Re: Response to Planning Comments - File Review for Project No. 13-20-0158 / Township of Langley

BC BUILDS - ALDERGROVE

FRASER HWY & 272
STREET, LANGLEY BC

sheet no. A1.03

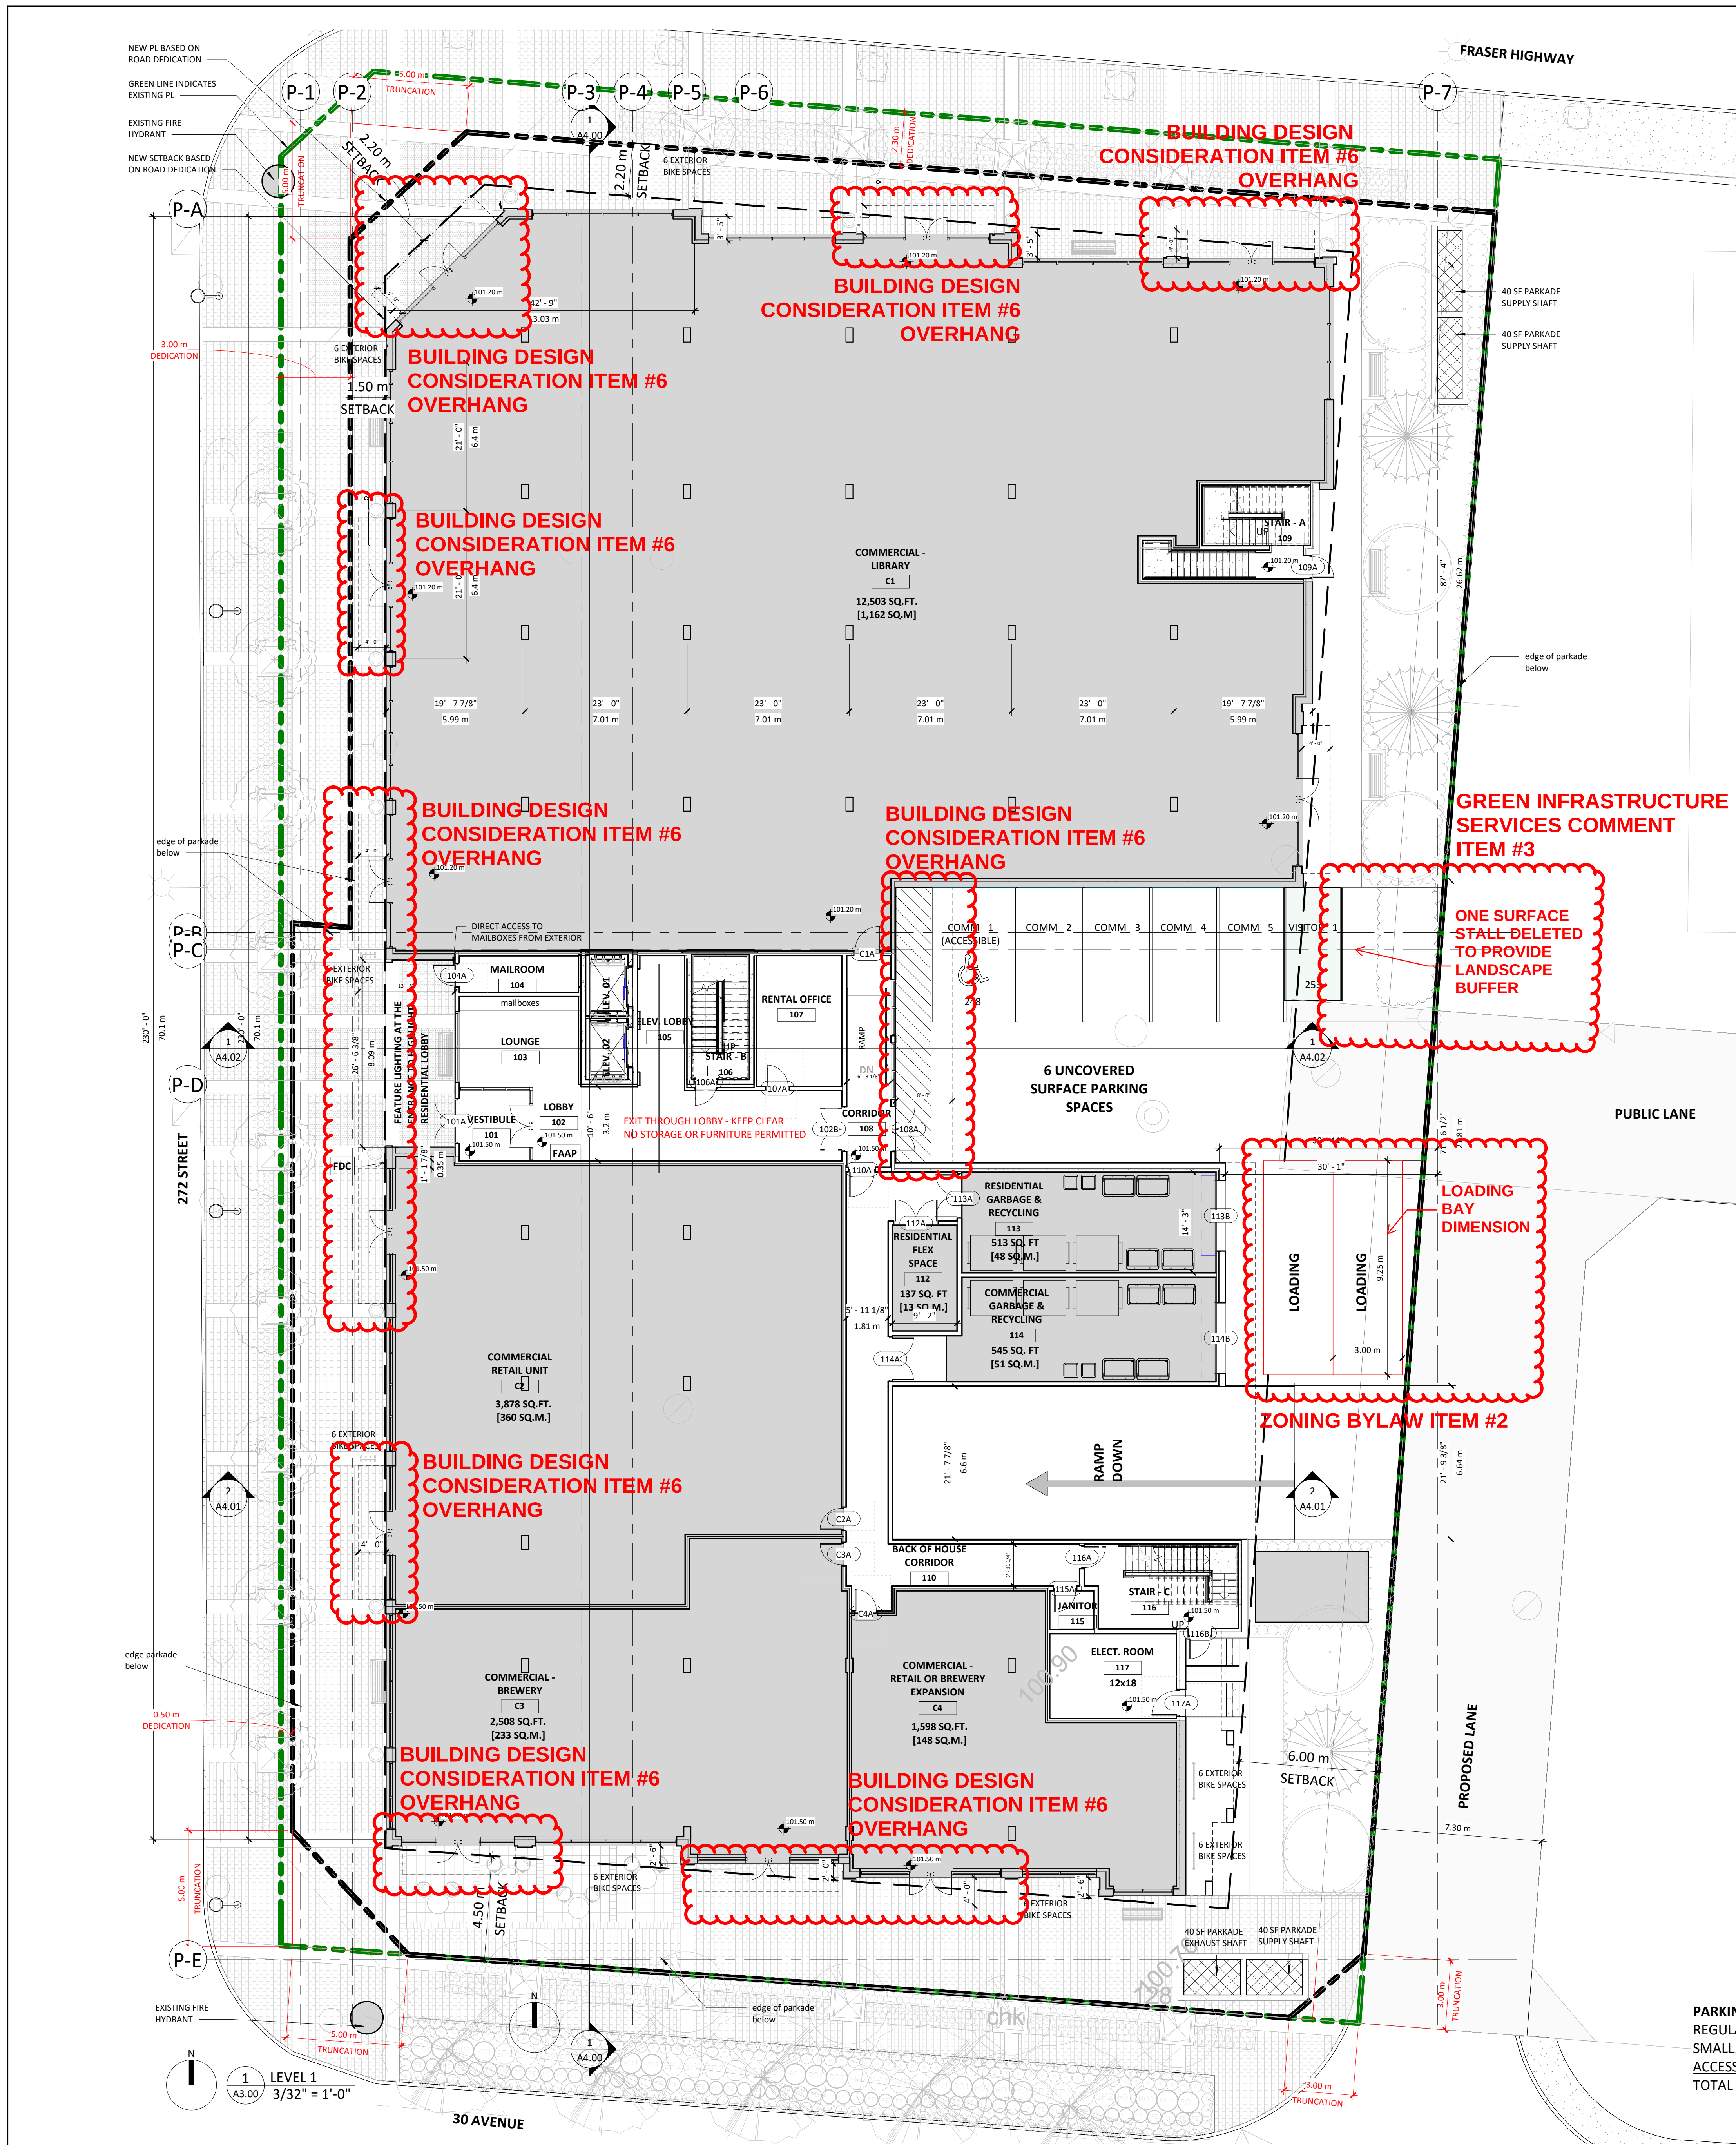
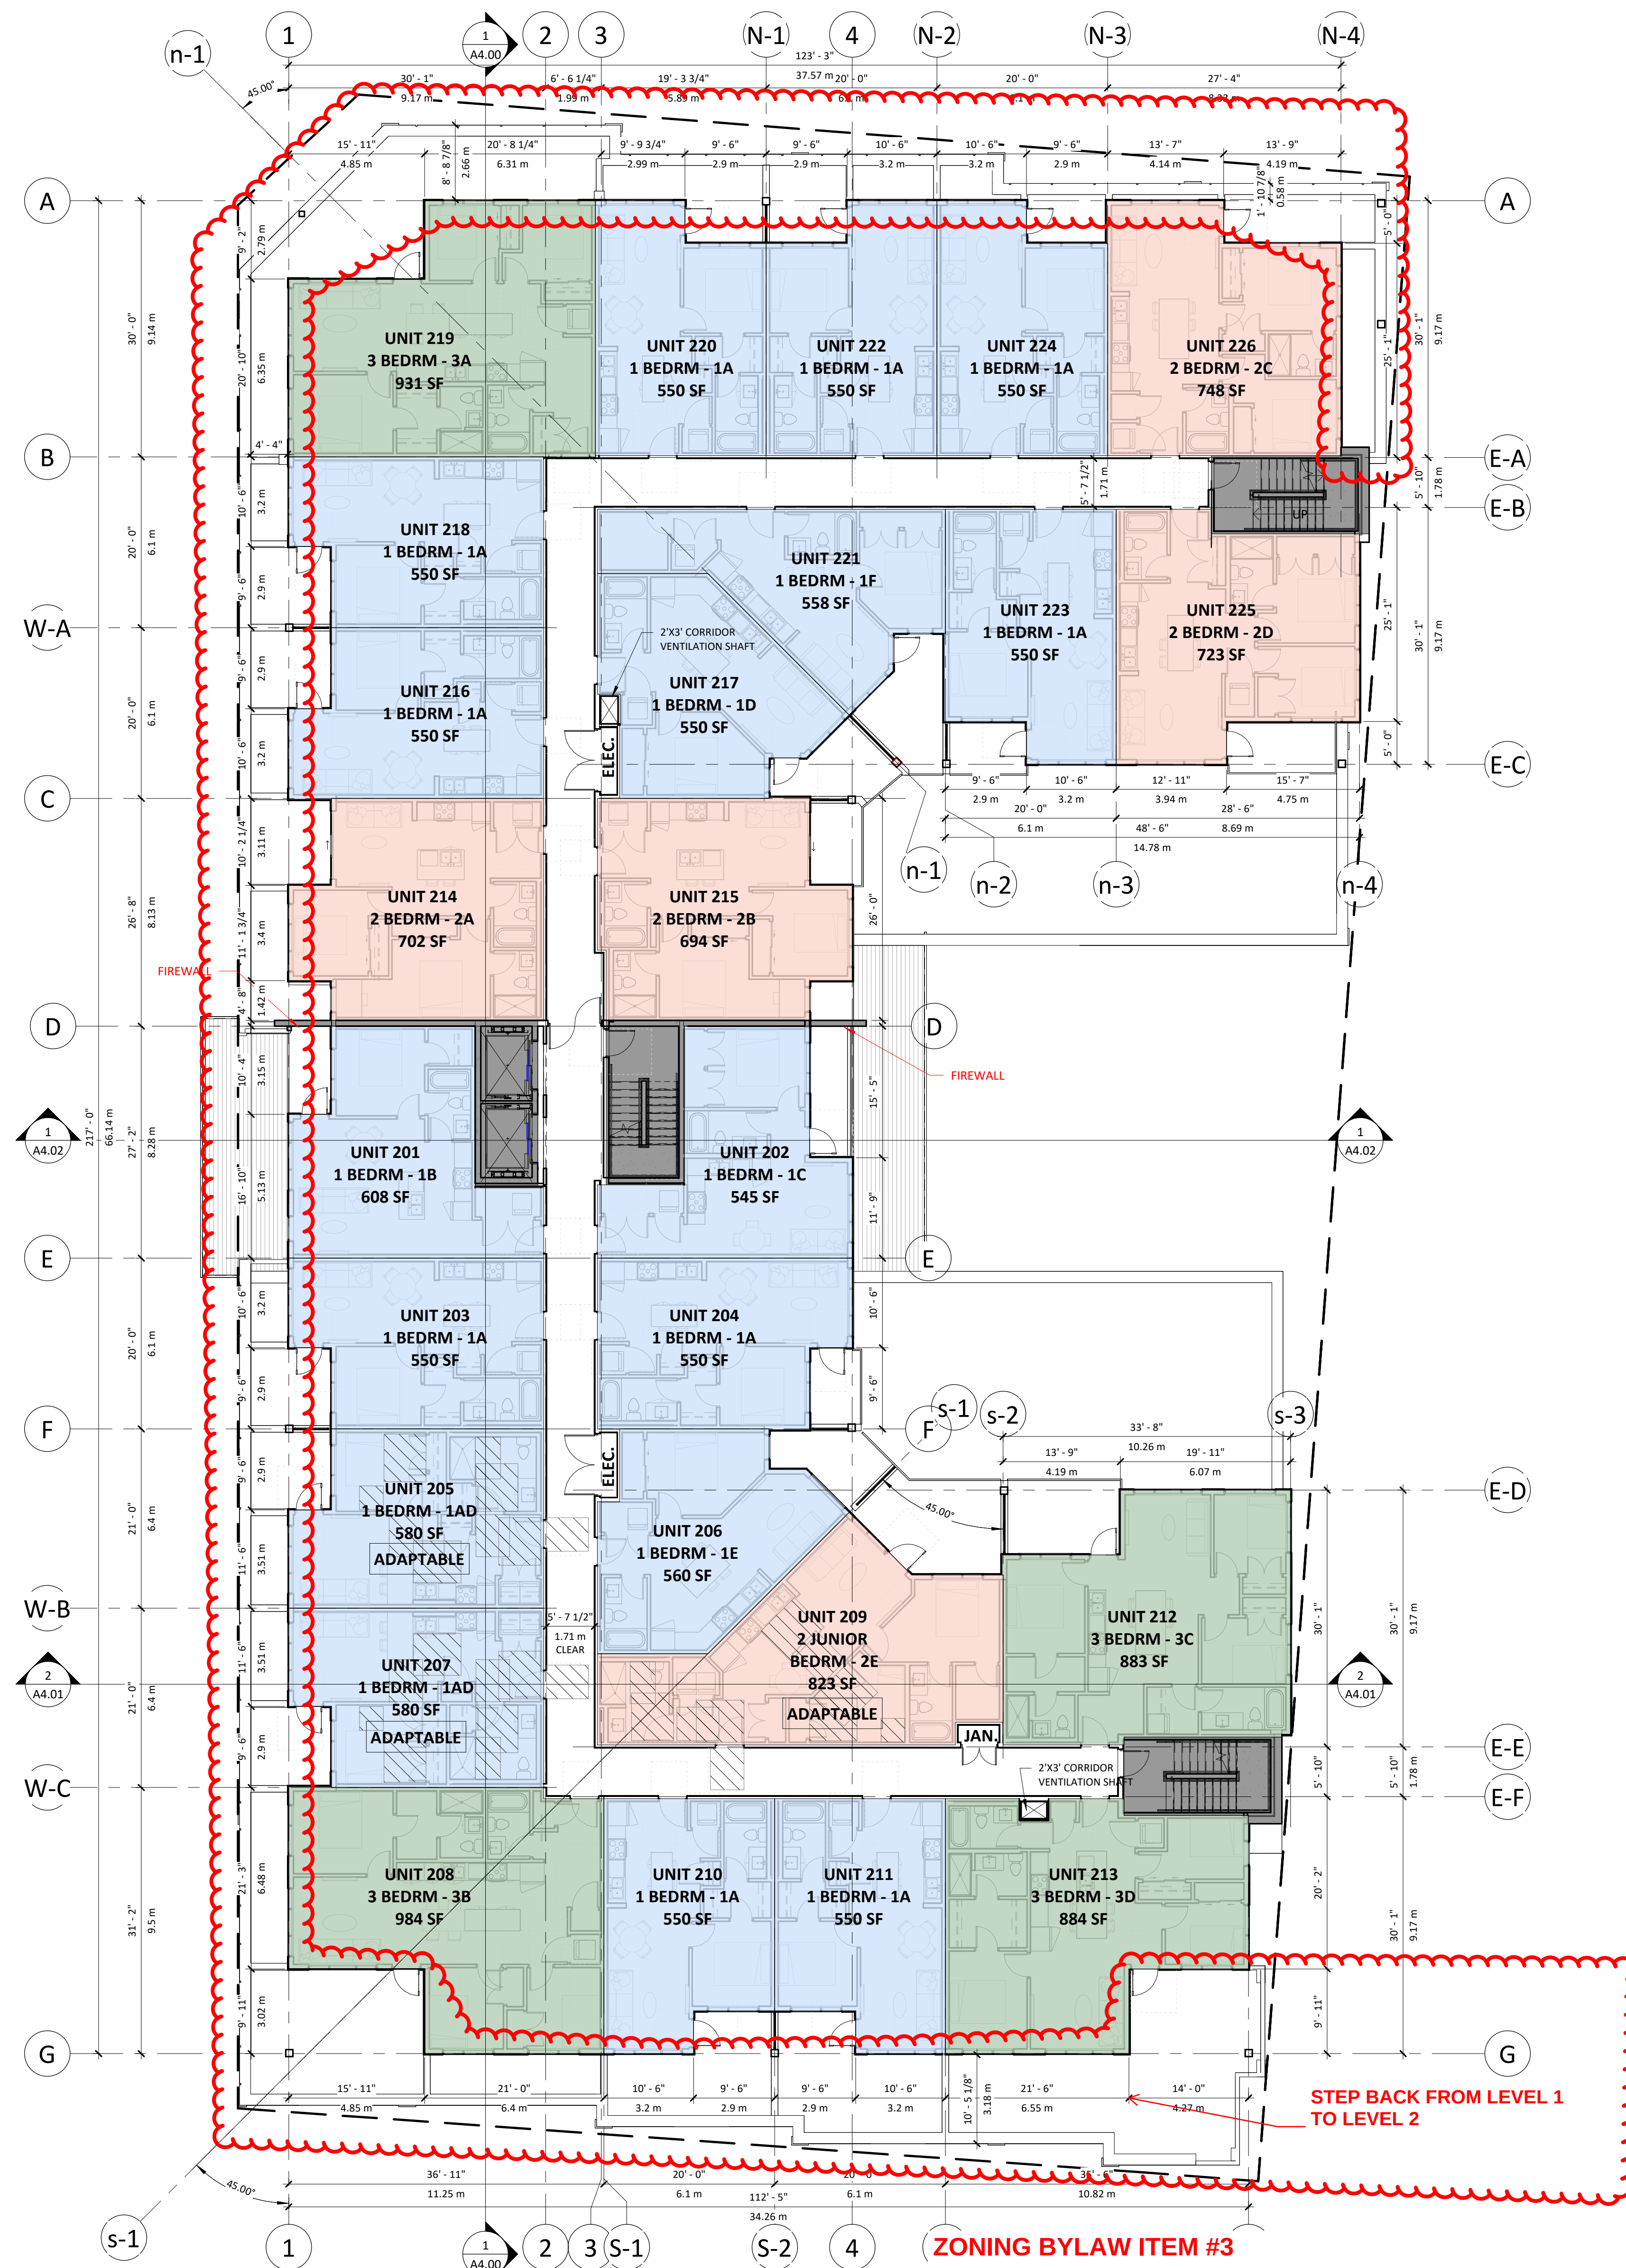
- **Floor Space Ratio is based upon the net site area excluding road dedication and corner truncation. FSR is consistent with the zoning bylaw definition.**
2. Some measurements have been provided for parking stalls. Please provide confirmation of:
 - a. In spaces that are not shown with measurements, please clarify if standard measurements are being used and provide information on what these measurements are.
 - b. That the proposed spaces comply with Section 105.6 Design Criteria in terms of width, length, and drive aisle widths.
 - c. Please provide loading space measurements and information on compliance of Section 107.8.

3. Section 105.6 permits a maximum of small car spaces for visitor and commercial spaces. Accordingly, please revise your proposal to reflect:
 - a. a maximum of 20% of total permitted visitor stalls as small car spaces
 - b. a maximum of 20% of total required commercial parking spaces

- **Please see updated plans for dimensions. In spaces without dimensions, standard measurements are used as per Section 107.5 Design Criteria.**
- **Vehicle parking stalls and loading spaces comply with the requirements. Please see sheet A1.03 for loading bay dimensions.**

- **Small car parking count has been revised to reflect the requirements. Please see revised calculation on sheet A1.00 and revised plans on A1.01, A1.02, and A1.03.**
